PIC32MX534/564/664/764 Family Silicon Errata and Data Sheet Clarification

The PIC32MX534/564/664/764 family devices that you have received conform functionally to the current Device Data Sheet (DS60001156H), except for the anomalies described in this document.

FIGURE 1: EXTERNAL COMPARATOR SCHEMATIC EXAMPLE

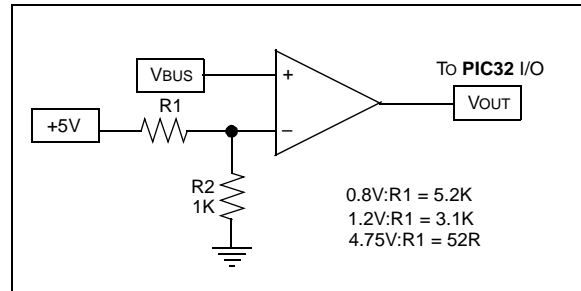
When the USB model is configured for OTG operation, it may not recognize all required OTG voltage levels on VBUS pin.

Use external comparator circuit to detect OTG specific voltage levels on VBUS pin.
